Docket Number:	18-IRP-01
Project Title:	Integrated Resource Plan
TN #:	230957
Document Title:	Updated - Staff Paper - Review of Los Angeles Department of Water and Power's 2017 Power Integrated Resource Plan
Description:	** This document supersedes TN# 229656 for accessibility purposes. **
Filer:	Courtney Wagner
Organization:	California Energy Commission
Submitter Role:	Commission Staff
Submission Date:	12/2/2019 2:37:37 PM
Docketed Date:	12/2/2019

STAFF REPORT

Review of Los Angeles Department of Water and Power's 2017 Power Integrated Resource Plan

Gavin Newsom, Governor
September 2019 | CEC-200-2019-015

Figure 1: LADWP and CEC Energy Forecasts 2018-2030 (GWh)

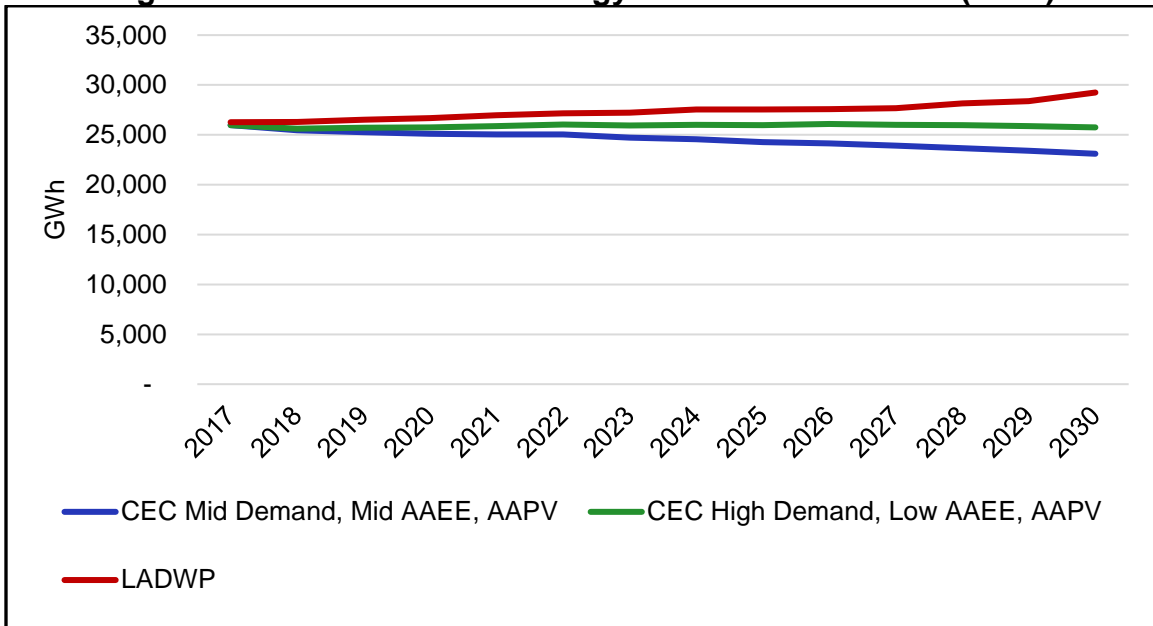
The CEC's energy demand forecast for LADWP in the high demand case (low AAEE and AAPV) remains relatively flat over the forecast periods,⁹ while the mid demand case (mid AAEE and AAPV) decreases.¹⁰ Both CEC forecasts are lower than LADWP's forecast as shown in **Figure 1**.

Figure 2: LADWP and Energy Commission Peak Forecasts 2018 — 2030 (MW)

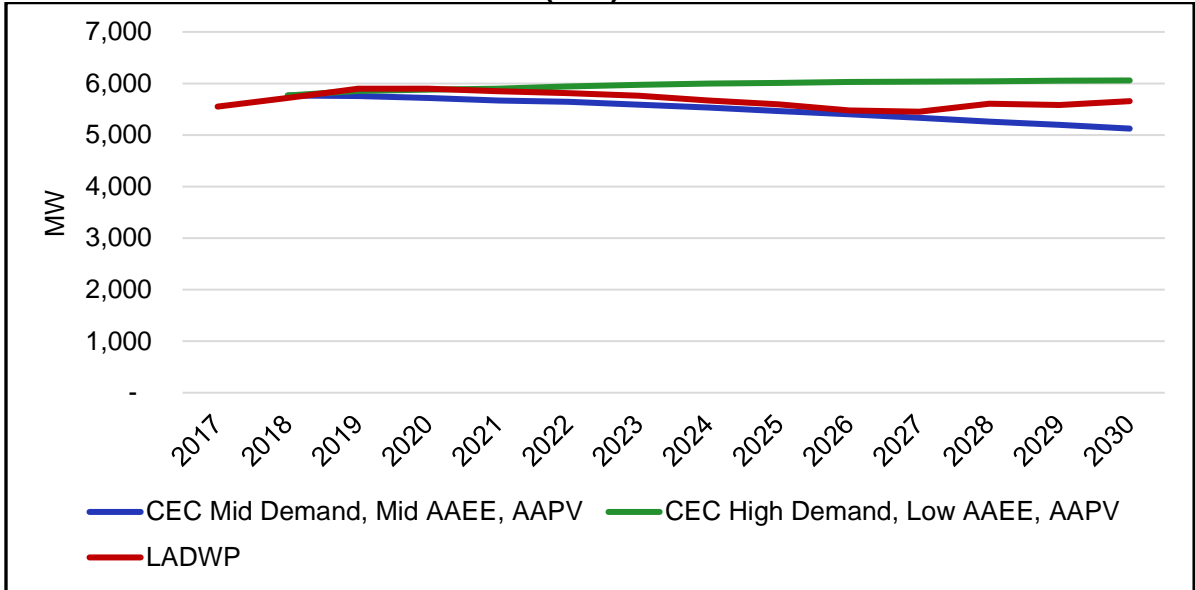
Figure 2 shows a comparison of LADWP’s peak demand forecast with the CEC’s forecasts. The CEC’s high demand forecast (low AAEE and AAPV) is relatively flat over the forecast period, while the mid demand case (mid AAEE and mid AAPV) shows a modest decline. For this figure, LADWP’s forecast falls between the CEC’s two cases.
